7C Defense Against Common-Mode Failure in Safety-Related, Software-Based I&C Systems

The information in this appendix of the reference ABWR DCD, including all subsections and figures, is incorporated by reference with the following departures.

STD DEP T1 3.4-1 (Figure 7C-1)

Figure 7C-1 Implementation of Additional Diversity in SSLC to Mitigate Effects of Common-Mode Failures

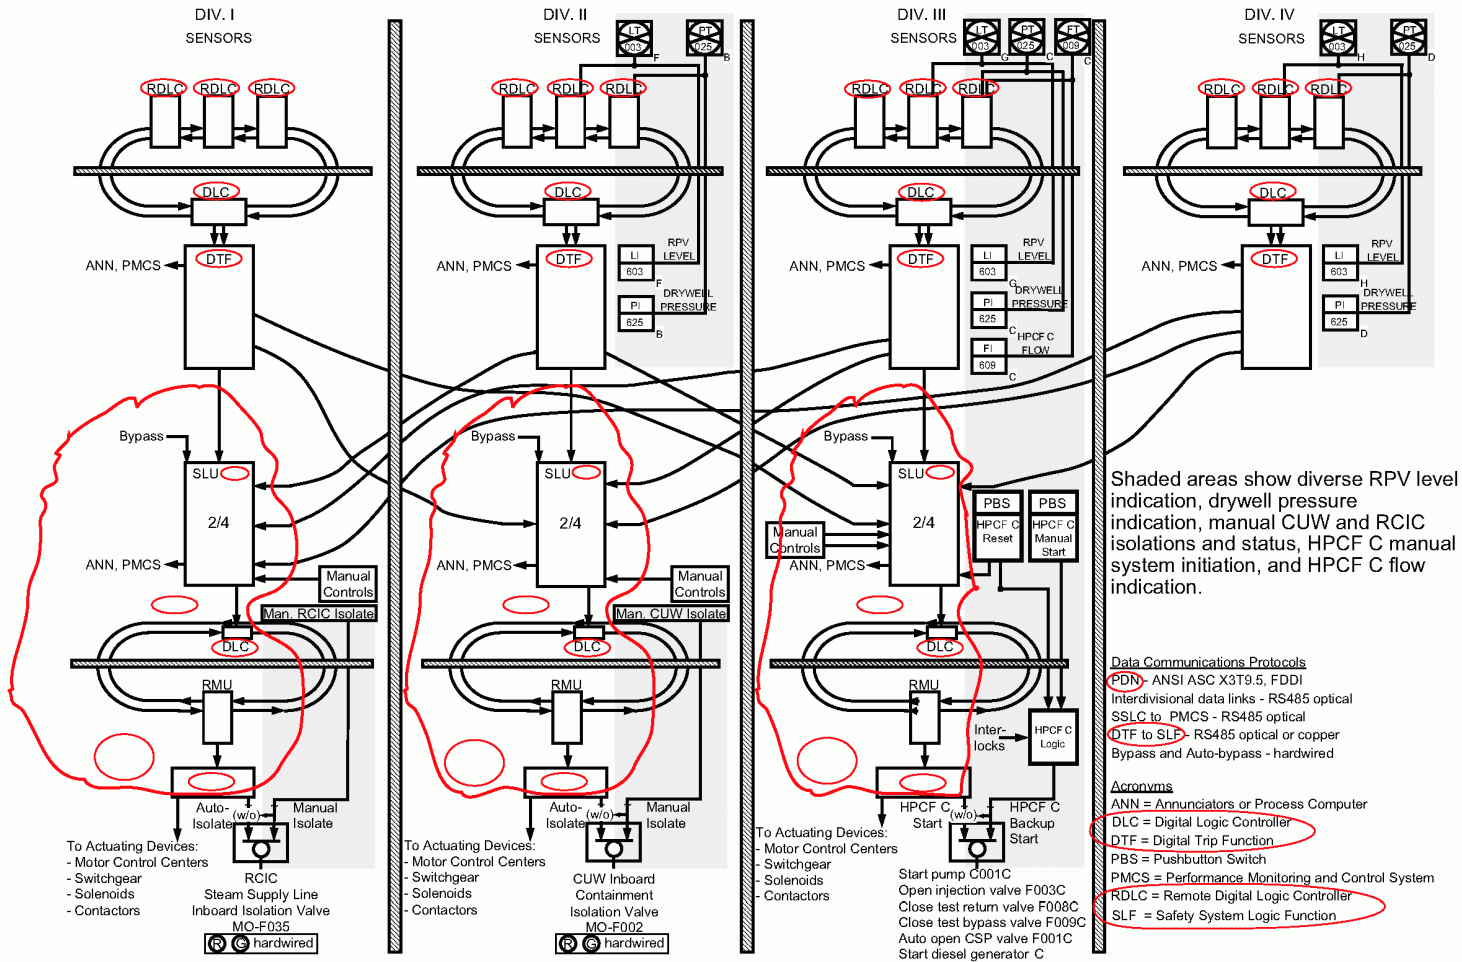
STD DEP T1 3.4-1 (Figure 7C-1)

STD DEP T1 3.4-1 (Figure 7C-1)

STD DEP T1 3.4-1 (Figure 7C-1)

STD DEP T1 3.4-1 (Figure 7C-1)

- (2) Defense-in-depth configuration:
 - (a) Fail-safe RPS and fail-as-is ESF in separate processing channels
 - (b) Control systems ~~supporting diverse injection~~ are independent of RPS and ESF in separate triplicated processing network using diverse hardware and software from the ~~Essential Multiplexing System~~ Essential Communication Function (ECF) network
